Erection of 1 ¹/₂ Storey Extension to the Rear Elevation

23 Elie Avenue Broughty Ferry Dundee

Report by Executive Director of City Development

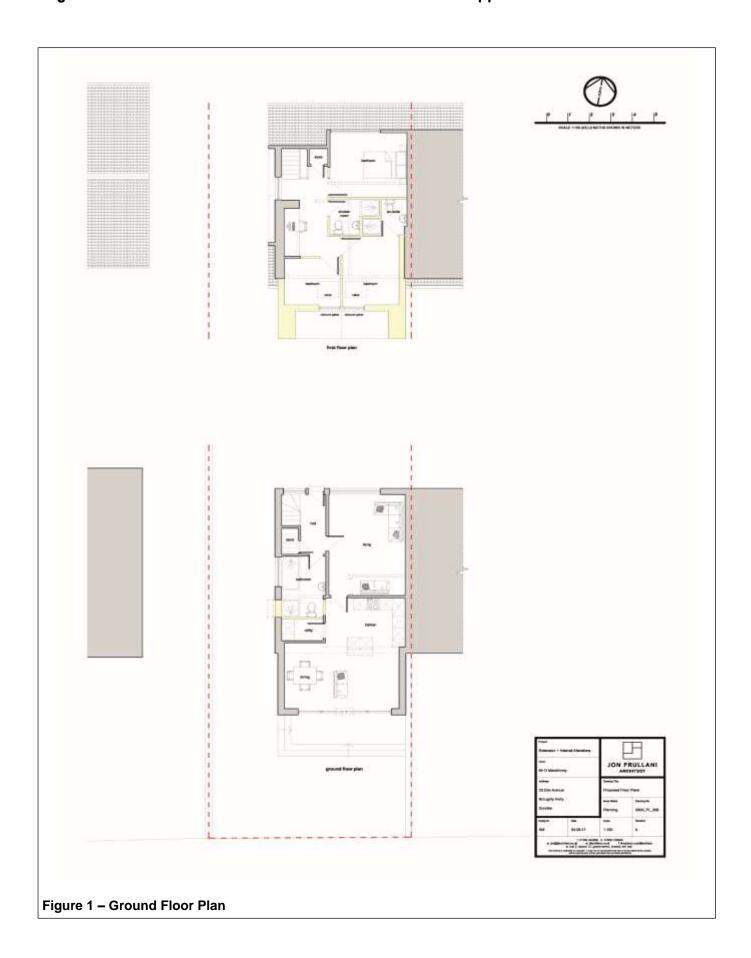
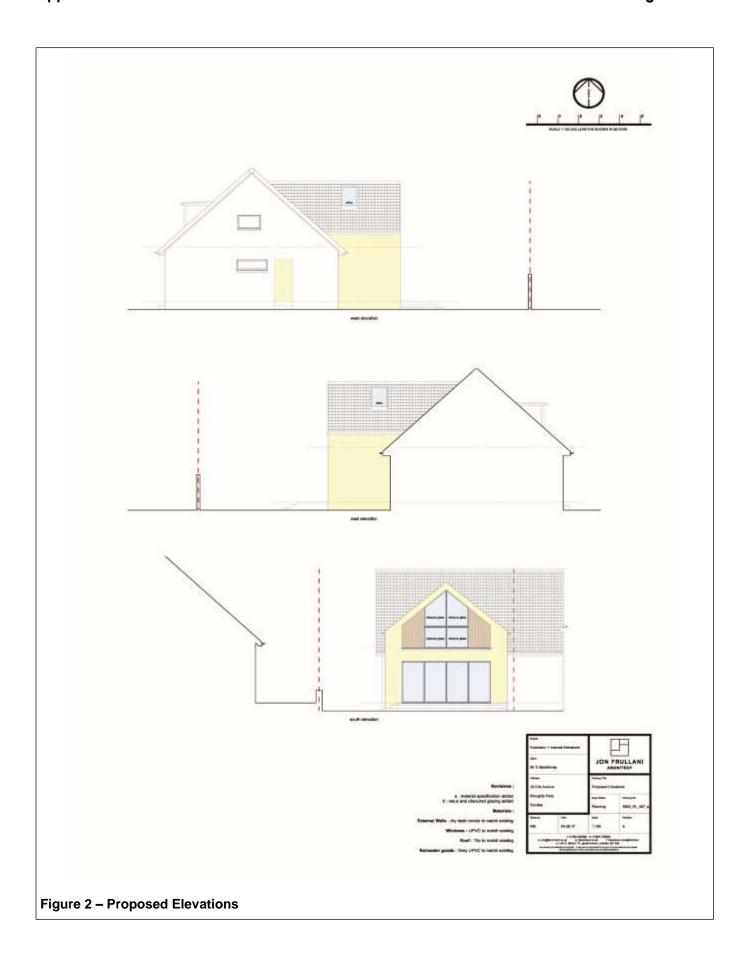
The applicant initially proposed significant areas of glazing to the south elevation, with proposed first floor windows serving two bedrooms. However, the windows were within 16 metres of windows on 17 Falkland Place to the south and within 7 metres of neighbouring garden ground. This raised overlooking and privacy concerns. To address these concerns the applicant has amended the extension to provide 18 metres separation between first floor windows and windows of neighbouring property. In addition, first floor windows to the south elevation have been reduced in size and are to be fitted with obscured glazing. The proposed roof lights to the east and west roof planes are of a size and position which do not raise any overlooking concerns. Subject to the provision of obscured glazing to the south elevation, the proposed extension would have no impact on neighbouring properties by means of overshadowing, overlooking or physical impact.

- 9.1 It is recommended that consent be GRANTED subject to the following conditions:
 - 1 **Condition** the first floor south facing windows serving proposed bedrooms shall be obscurely glazed and maintained as such in perpetuity.
 - **Reason** in the interest of residential amenity and privacy.
 - 2 Condition no access shall be afforded to the first floor south elevation recess and no balcony shall be formed.
 - **Reason** in the interest of residential amenity and privacy.
